Planning Observation

**Mixed-Use Commercial & Residential Development
Reg. Ref. SD21A/0271**

**Land at 'The Silver Granite' Pub,
Kennelsfort Road Upper and Wheatfield Road,
Palmerstown, Dublin 20**

4th November 2021

Figure 16.0 Proposed site layout plan showing separation distances between proposed development and existing dwelling southeast of the subject site (~30.8m and 36.2m)

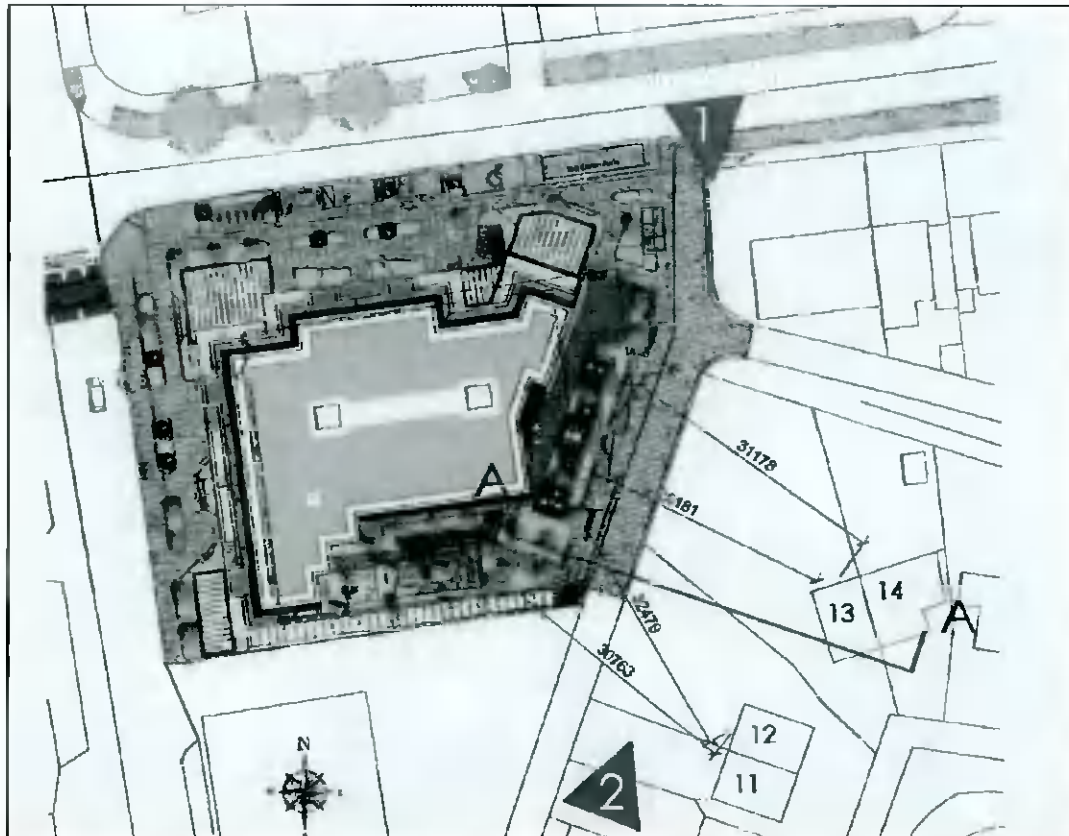
It is considered that the proposed development will result in significant overlooking of the residential dwellings located immediately to the east and south east of the development. Whilst we note a separation distance of between 30.8m and 36.2m has been achieved between the rear, south and eastern, boundary to the properties at Nos. 12-13 Oakcourt Grove and No. 1-3 Wheatfield Road, this distance is considered inadequate given the extent of private balconies proposed on the elevation of this apartment block, see Figure 16.0.

Figure 17.0 Shadow diagram from Daylight and Sunlight report (21 June 18 00 GMT +1)

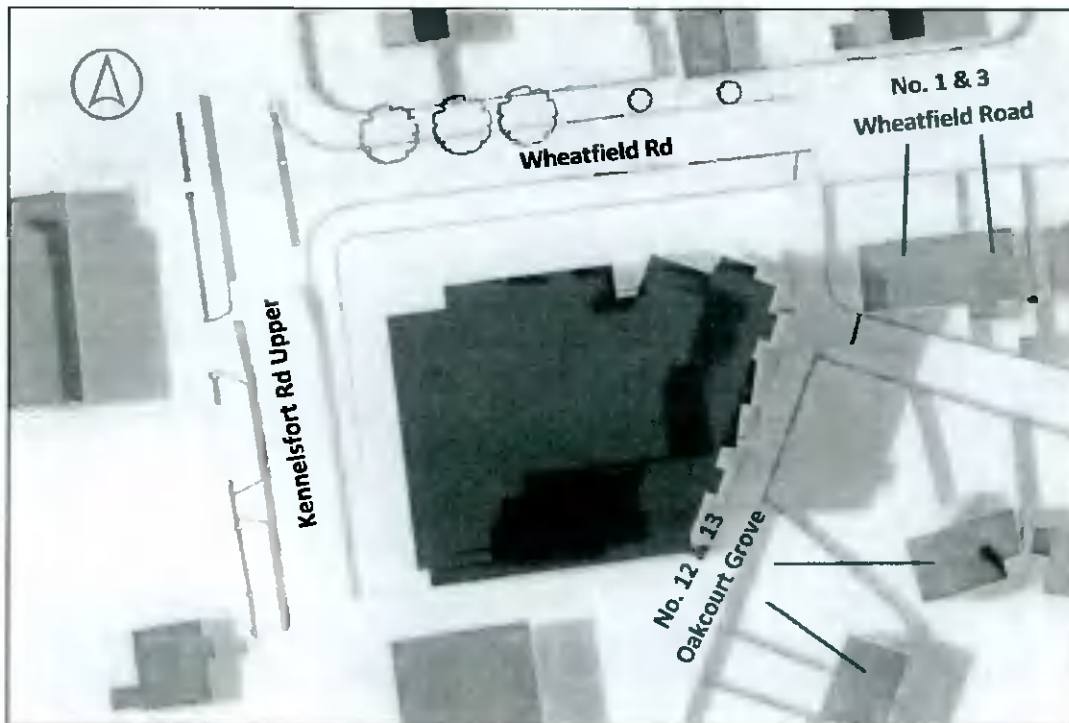
We count 6 no balconies on Proposed Elevation 3 submitted with the project, the vast majority of which will have direct views towards these properties, and in excess of windows above first floor level. It is considered that this elevation will cause unreasonable overlooking of the aforementioned neighbouring residential dwellings, along Wheatfield Road and the laneway accessed from Wheatfield Road, and will also affect residential amenity by way of the perception of overlooking. The proposal is stated to be 'a high-quality development at an underutilised site within an urban setting' and that 'the proposed development will provide appropriate levels of daylight and sunlight and will not give rise to adverse overshadowing'. We refer to the proposed shadow diagram from the Daylight and Sunlight report submitted by applicant, see Figures 17.0-18.0.

Figure 19.0 Schematic Section AA showing separation distances between proposed development and existing dwelling at 13 Oakcourt Grove.

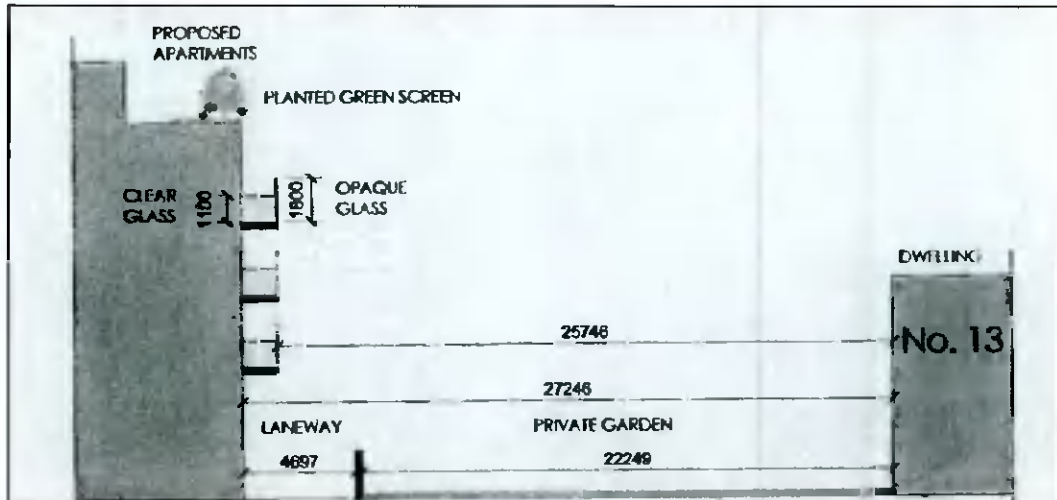
As noted above, the first through fifth floors of the proposed development will serve as dual aspect residential units. If the proposed development was permitted, it would result in severe overshadowing due to the height difference between the mixed-used development and the existing residential dwellings. The overbearing structure which is quite significant in mass and scale in the local context would have detrimental effects on the residential amenity currently afforded to these dwellings.

Figure 21.0 3D Study looking northeast and from laneway toward Wheatfield Road.

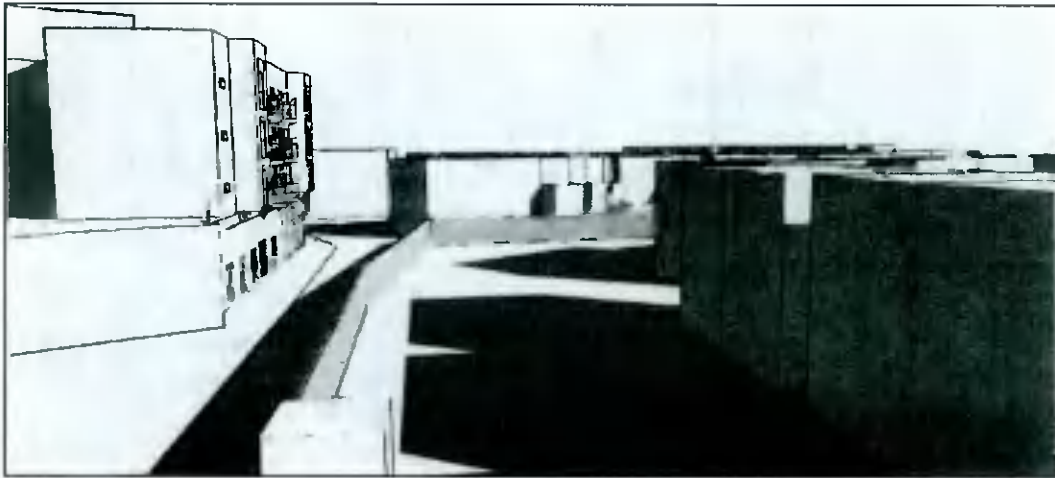
The development is over-scaled and bulky and is expected to result in overshadowing of these properties, particularly No. 1 & 3 Wheatfield Rd, Johnstown, Dublin 20 as well as the rear yards of Nos 12 & 13 Oakcourt Grove, Johnstown, Dublin 20
